Appendix H. Response to Public Comments on the Proposed Desalination Amendment and Staff Report with Substitute Environmental Documentation

Associated with the Draft Staff Report Including the Draft Substitute Environmental Documentation for the Proposed Desalination Amendment

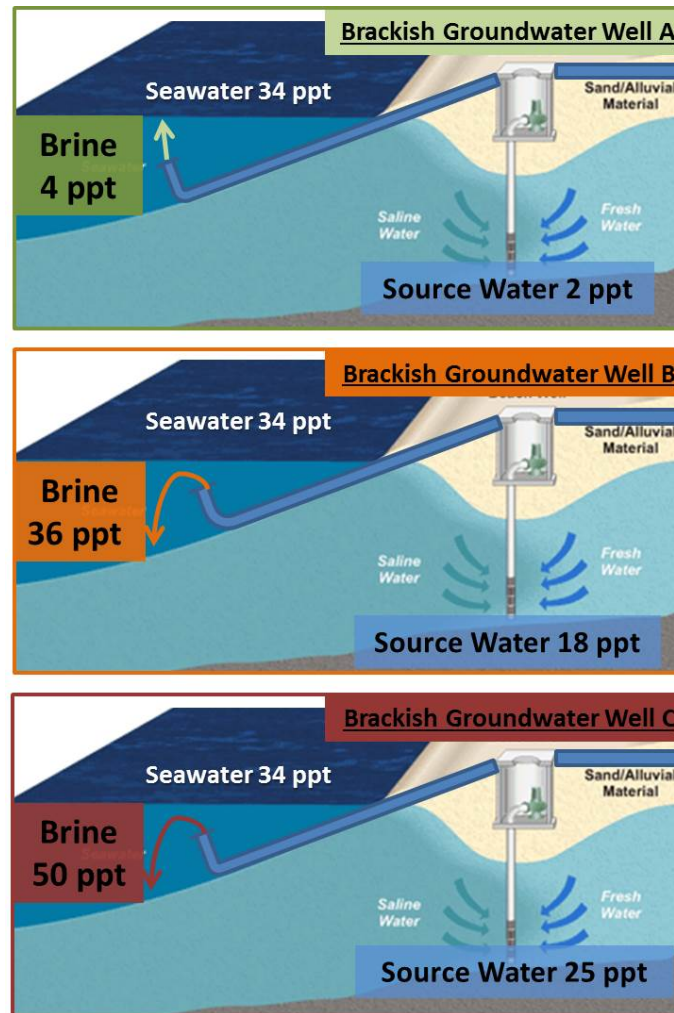
ID#	Comment Summary	Response
8.1	<p>As a threshold matter, we are concerned that with respect to the regulation of desalination facilities, the focus of the Draft Amendments is on ocean desalination facilities and not brackish groundwater facilities.</p>	<p>The scope of the proposed Desalination Amendment is intended to cover desalination facilities that intake seawater and discharge brine into ocean waters. In the proposed Desalination Amendment, seawater is defined as:</p> <p style="text-align: center;"><i>“salt water that is in or from the ocean. For the purposes of chapter III.L, seawater includes tidally influenced waters in coastal estuaries and lagoons and underground salt water beneath the seafloor, beach, or other contiguous land with hydrologic connectivity to the ocean.”</i></p> <p>The definition of seawater covers facilities that withdraw seawater through subsurface intakes. In some cases, the salinity of the subsurface water will vary based on environmental factors, like tidal fluctuations, which may result in the seawater periodically being brackish. Brackish water has salinity that is higher than potable water, but lower than seawater. Salinity concentrations of brackish water range from 1,000 mg/l total dissolved solids (TDS) to 25,000 mg/l TDS. (U.S. Department of the Interior Bureau of Reclamation 2014: http://www.usbr.gov/research/AWT/brackish.html)</p> <p>The scope of the proposed Desalination Amendment is not intended to include intakes from water recycling facilities and groundwater desalination facilities unless those facilities intake seawater. Additionally, brine discharges or reject water from water recycling efforts are significantly less saline than brine discharges from seawater desalination facilities and less saline than seawater, meaning they are neutrally or positively buoyant. Consequently from a salinity standpoint only, brine discharges from water recycling efforts do not pose a significant threat to water quality or other related beneficial uses of ocean waters because the salinity of the wastewater is typically far below natural background salinity of ocean water. For these reasons, brine discharges from water recycling efforts should not be covered under the scope of the proposed Desalination Amendment.</p> <p>Brackish groundwater has a wide range of salinities. By definition, brackish is a combination of fresh water and salt water and can range</p>

ID#	Comment Summary	Response
		<p>for salinity that would apply to all brackish groundwater desalination facilities in California.</p> <p>Figure 8.1-1 below presents three brackish groundwater desalination facilities with different source water and brine salinities measured in ppt. The figure illustrates how varying salinity of source water can influence the density of the discharged plume. Facility A produces a positively buoyant “brine” plume that would not affect the benthic marine environment. Facilities B and C would form dense, negatively buoyant plumes that could negatively affect the benthic marine environment if not properly discharged.</p> <p>Currently, regional water boards issue waste discharge permits (either WDRs or NPDES permits) for brackish water desalination facilities on a case-by-case basis. More research is needed to identify an appropriate statewide limitation to apply to brine discharges from brackish groundwater desalination facilities. The Staff Report with SED does not adequately study brackish groundwater desalination facilities and staff would need additional time to research the impacts associated with the facilities and incorporate the information. Furthermore we would need to meet with stakeholders in the brackish groundwater desalination facility community to solicit feedback on the proposed Desalination Amendment language. Brackish groundwater desalination facilities are currently regulated by the regional water boards on a case-by-case basis. However, if there is sufficient public interest the State Water Board may address the issue in a subsequent amendment to the Ocean Plan.</p>
